August 24, 2021

**Subject: Review of 2020 Annual *Groundwater Management Zone (GMZ) Monitoring and System Performance Report*
Hamilton Sundstrand Corporation (HSC) Plants 1/2 Facility
Area 9/10 Remedial Action
Southeast Rockford Groundwater Contamination Superfund Site, Rockford, Illinois
*ILD981000417***

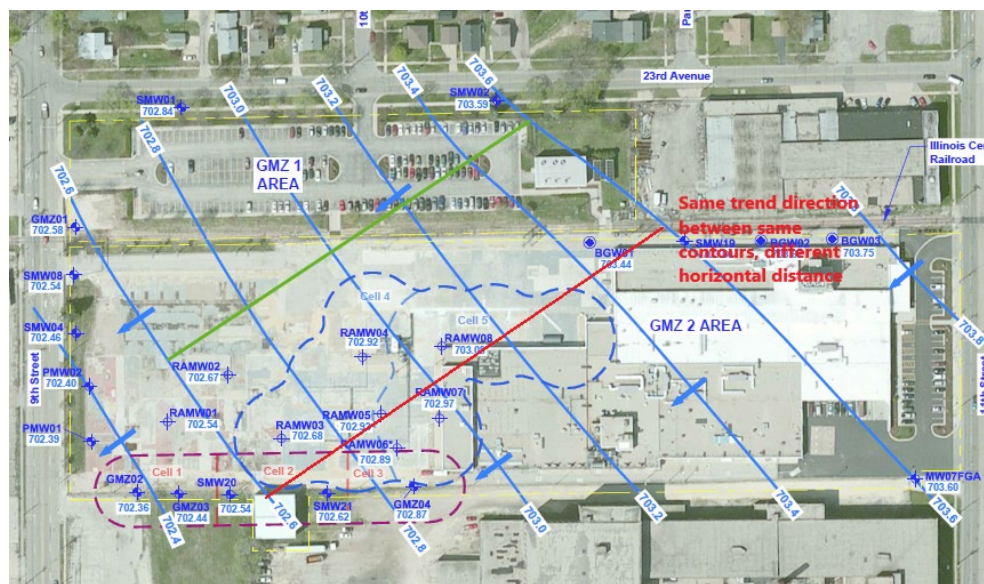
3. Consider including an evaluation of water level impacts on contaminants of concern (COCs) at SA 9/10 in this and future Annual Reports. This could include long-term and short-term (i.e., that year's data) evaluation of groundwater level fluctuations, flow patterns (pre remedy and system pulse on/off affects) along with corresponding analytical data, and river stage data (hydrographs). Evaluating these types of fluctuations particularly with respect to the western wells, the OSA, and MCL exceedances may provide another line of evidence to sort out impacts along the western GMZ boundary.

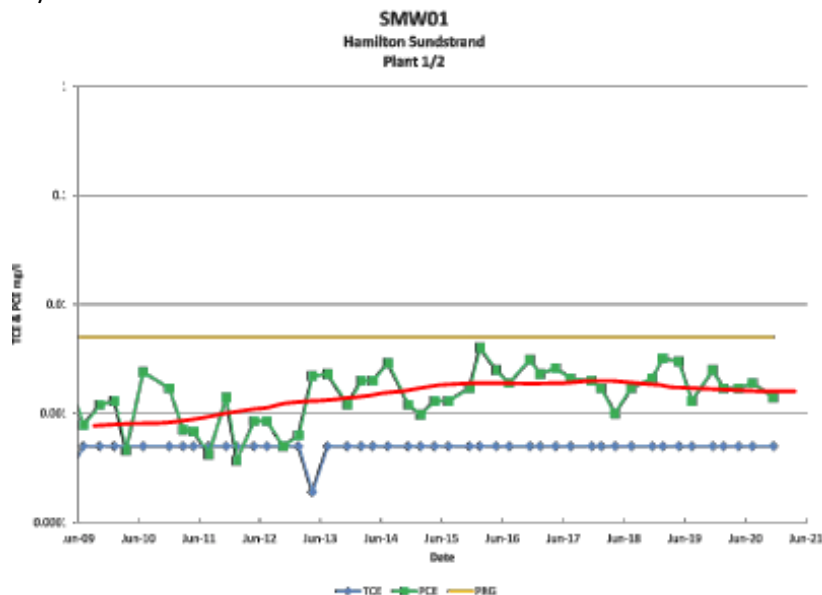
- b. Last Sentence. This statement appears to be overconfident. When taken in shorter periods of time, there are multiple increasing trends in the time series data. Also, SMW01 shows an increasing trend in PCE in the overall time series plot (see plot below). For further clarification see EPA's 1Q 2021 Comment Letter (General Comment #3) regarding trend interpretation(s). Furthermore, how are conditions downgradient improving as downgradient of the western GMZ 1 and 2 boundary, sample results are not presented/assessed?
